ASSESSMENT REPORT

Remediation, Hickson Road, Barangaroo DA 6617 MOD 1

Figure 3: Proposed compound works extension Stage A1 situated south of Hickson Road (Source: EIS MOD 1 SSD 6617)

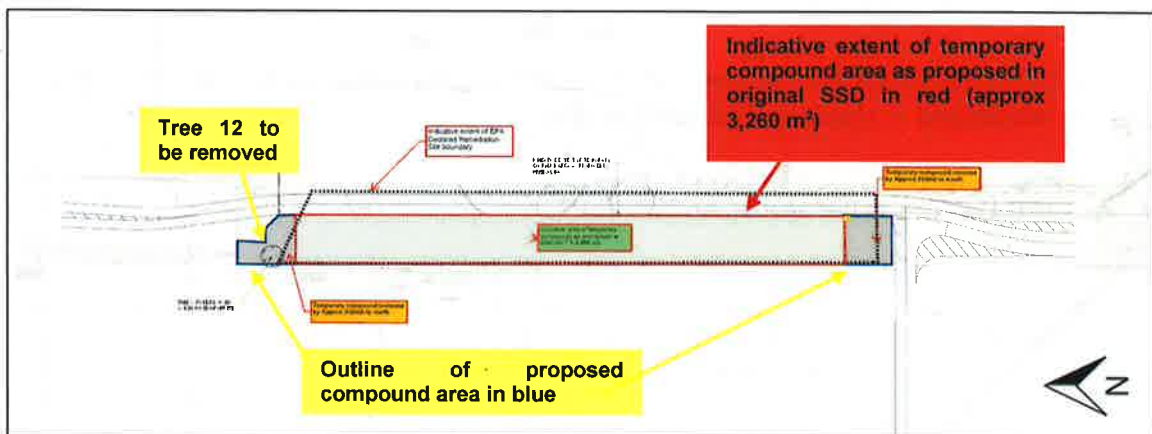
MOD 1 seeks approval under section 96(1A) of the *Environmental Planning and Assessment Act 1979* (EP&A Act) to extend the two temporary compound work areas (known as Stage A1 and Stage B1) currently located within Hickson Road. As a result, a portion of the compound areas (north and south) would sit outside the EPA remediation area within Hickson Road (**Figures 3 and 4**).

The Stage A1 area would increase in size by 230 m² to north and 250 m² to the south. The Stage B1 area would increase in size by 95 m² to the north and 45 m² to the south. The purpose of the expansion is to provide more space for the storage of materials and equipment needed for the Hickson Road remediation works.

The proposed extension of the Stage A1 compound area would increase its size by 230 m² to the north and 250 m² to the south resulting in an overall area of 3,760 m². The proposed extension of the Stage B1 compound area would increase its size by 95 m² to the north and 45 m² to the south resulting in an overall area of 2,476 m². The extensions would represent an increase of 15 % and 6% for the Stage 1A and Stage 1B areas respectively.

The Department notes the increase in the temporary works compound areas are necessary to facilitate the remediation of Hickson Road and additional space is required to accommodate the remediation equipment and materials. The Department is satisfied the scope of the remediation works would not increase and therefore the expanded compound areas would not result in increased environmental impacts, particularly in respect of noise and odour impacts.

The Department is also satisfied the expanded compound areas would not reduce vehicular access along Hickson Road, with all traffic movements being managed through the staging of

the works which would rely on the two different compound configurations outlined in Stage 1A and Stage 1B (**Figures 3 and 4**).

The Department considers the extension of the temporary compounds to be acceptable.
